UNITED STATES NUCLEAR REGULATORY COMMISSION'S
ADVISORY COMMITTEE ON REACTOR SAFEGUARDS

July 9, 2008

554TH MEETING

ADVISORY COMMITTEE ON REACTOR SAFEGUARDS (ACRS)

P-19 Permissive

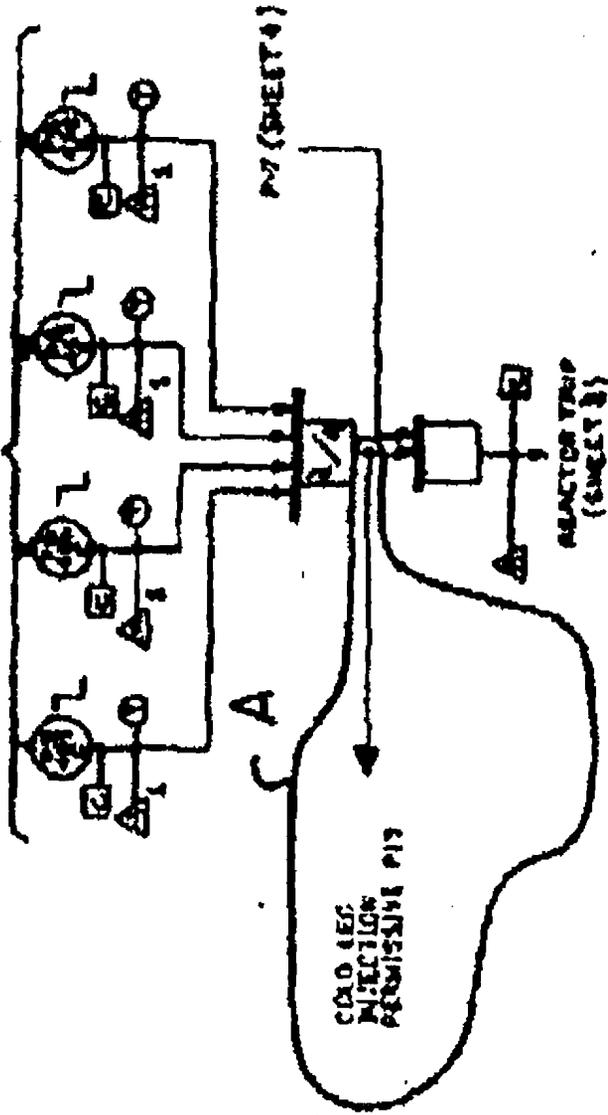
19 MEMBER CORRADINI: Is this permissive P19
20 in other Westinghouse plants and it just wasn't here
21 historically or is this a permissive that's unusual?

23 PARTICIPANT: Are we going to hear --
24 well, maybe we won't hear anything. So what is the
25 change in that probability because of this permissive?

1 We have come up with a modification to the
2 ECCS system. It's called a permissive. It's P19.
3 What that does is it uses the reactor trip signal on
4 low pressurizer pressure as a permissive to open the
5 charging injection valves and the charging injection
6 valves only.

22 MR. KAI: This is not in anybody else's
23 plant, no.

15 So basically we reviewed over-pressure
16 protection. And we asked them some questions about
17 what trips they were analyzing. We then reviewed the
18 implementation of the P19 permissive, which is
19 associated with the inadvertent ECCS actuation. The
20 staff's opinion in that regard is that the P19 is a
21 prudent implementation. We agree with it. And so we
22 were satisfied with that.

RG 1.60 Spectrum Anchored at 0.30 g (Fig. 1)

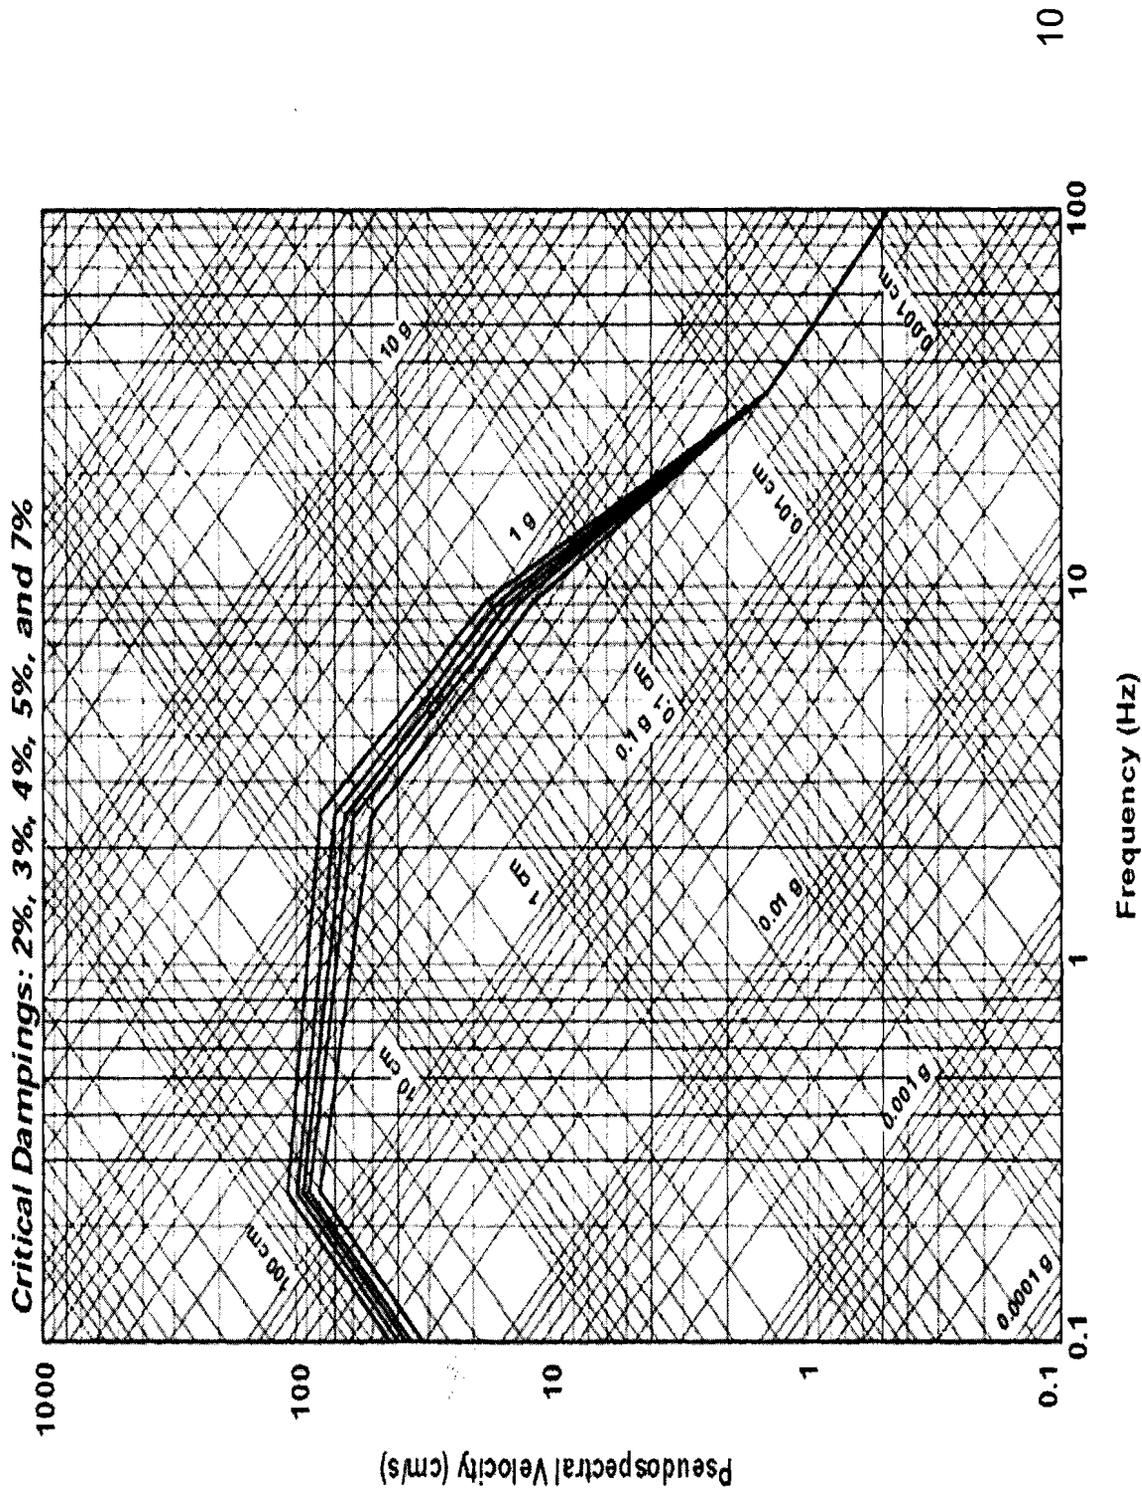
1 And in response to that request, the
2 industry has proposed to develop that portion of the
3 knowledge, and that is shown in the most site specific
4 ESP, that one response specter, and in my slides
5 Figure 1 is the regular 1.60 low range, and the Figure
6 2 -- this is Figure 1, in which shows our convention
7 of very important range of input and structure
8 response to aspect notion.

North Anna ESP Site Specific Spectrum
Anchored Approx. at 0.50 g (Fig. 2)

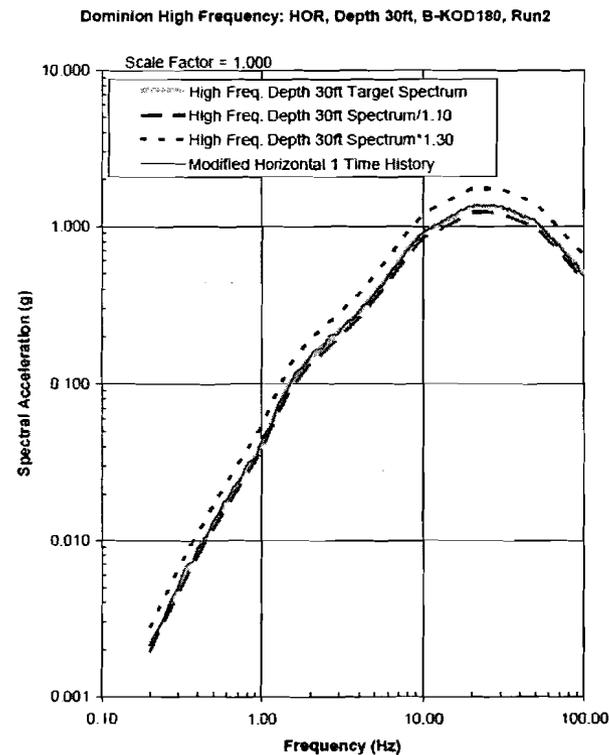
9 MR. JENG: This was Figure 2. Figure 2
10 is, again, different way of presentation of that high
11 frequency spectrum which is part of included in the
12 application DCD, and this shows the sequence 110 Herz
13 to 100 Herz. That's for the spectra radial far
14 exceeds dose observed in 1.60 growth between spectra.
15 That's why we are going to include that in our overall
16 design consideration.

ESBWR Certified Seismic Design Response Spectra (CSDRS) (GEH SLIDE) (Fig. 3)

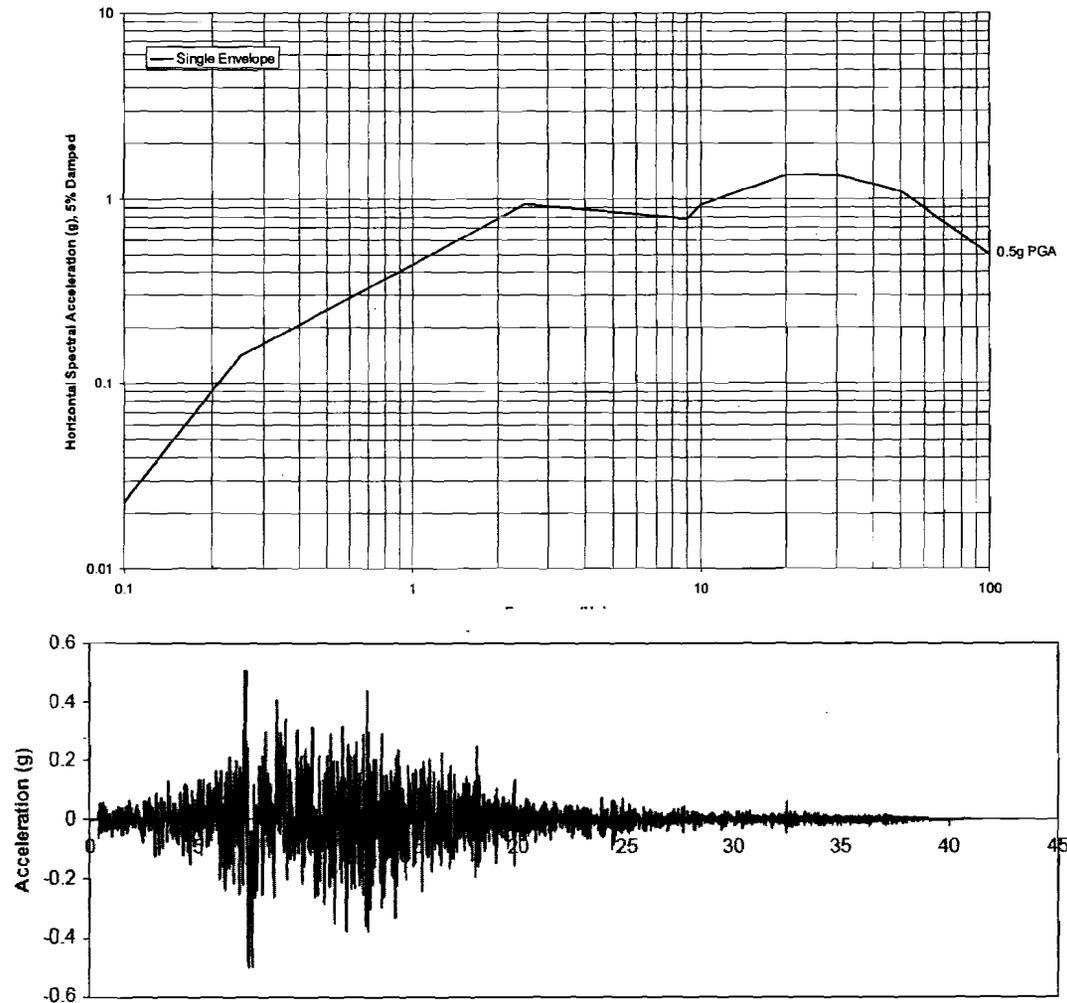
17 Let's go to Figure 3. This is a sort of
18 double hump design response spectra, certifies seismic
19 design with the spectra. This is a reference design
20 for which they are designed and they exert our
21 standard plan in the scope such as are able to take
22 whatever motion whose spectra stays in this bundled
23 envelope.
